AERONAUTICAL CHARTING FORUM
Instrument Procedures Group
Meeting 12-01 – April 24, 2012
HISTORY RECORD

FAA Control # 12-01-301

Subject: Publishing a Vertical Descent Angle (VDA) with 34:1 Surface Penetrations in the Visual Segment (*Also includes Issue 13-01-309 - LP Procedure Cancelled Because of VDA Not Being Charted).*

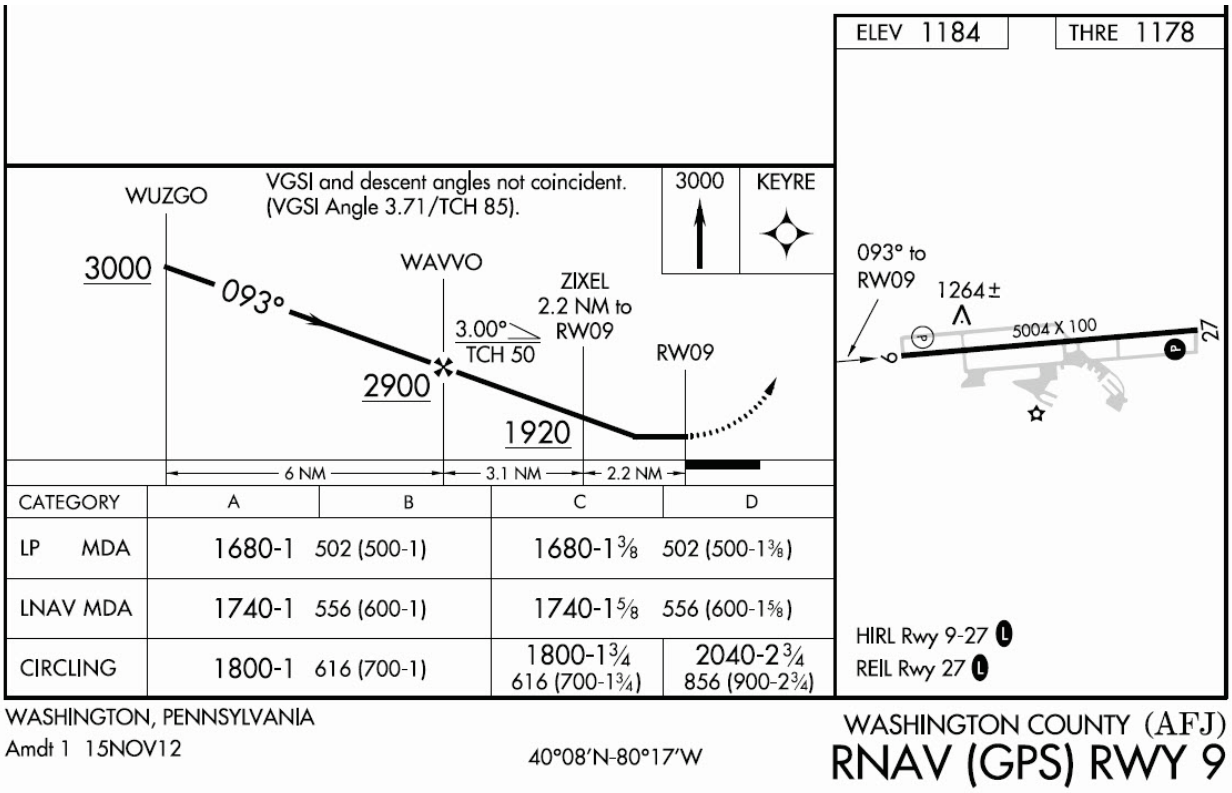
Attached is the back of the 8260-9. Could you point me to the reason for the deletion of LP? I cannot find it.

FLIGHT INSPECTION RESULTS DO NOT WARRANT A VDA

LP MINIMUMS DELETED

I called the Quality Advisor involved in the discussion to make sure I understood what was going on. He confirmed that the LP could not be published because it could not be coded with a VDA of 0 (zero). He indicated that the 0 was required to prevent advisory vertical guidance on the procedure.

I have several issues with this. The purpose for LP procedures is to provide a lower MDA than permitted by the LNAV where the smaller OCS footprint allows. It is only used when a vertically guided procedure isn't appropriate for the runway. Although a Constant Angle Non Precision Approach (CANPA) may be desirable, it is not always available as an option on all NPA procedures. The advisory glidepath provided by some manufacturers' GPS units is only permitted to be used during the descent to the MDA and not below it. It is my understanding that regardless whether a VDA is published or not, advisory vertical guidance may be provided, in that if the 8260 doesn't provide the data for the advisory glidepath, the manufacturer may calculate one. Therefore, setting the VDA to 0 in the database doesn't necessarily eliminate the advisory glidepath from the database. Because of the coding issue described by the Quality Advisor, the LP procedure is eliminated. It is ironic that the unintended consequence is that the LNAV will end up with an advisory glidepath, but if it is coded in the database it will not generate advisory guidance, at least in the Garmin units. This is because, the LP procedure in the Garmin units don't support advisory vertical guidance under any circumstance whenever LP is the highest service level coded for the approach, regardless if the integrity at the time of the approach supports LP or LNAV. My understanding of the ACF issue dealing with VDA was only to affect whether or not the VDA would appear on the chart and there was to be a note added to the effect "Descent Angle NA". This situation ends up being a 'catch 22', if the runway doesn't qualify for vertical guidance, and flight testing indicates that CANPA is not an option, it doesn't qualify for LP, and when a LP is coded it doesn't have advisory vertical guidance, but if only a LNAV is coded, it does have advisory vertical guidance.

This is the reason, but it has more to do with coding. Once we remove the VDA, the coding has to be changed 3.00 degrees to 0.00 degrees thus negating the LP minimums and the FAS DATA. If we kept the 3.00 degrees in coding it would override what we are trying to prevent. We are trying to prevent the aircraft flying from FAF to THLD, like an LPV /ILS, when it should be flying from FAF to MDA like an LNAV.

Recommendations: *The database coding of LP procedures should be permitted even when the VDA is not charted. Being able to fly a procedure with CANPA should not be a requirement for a NPA.*
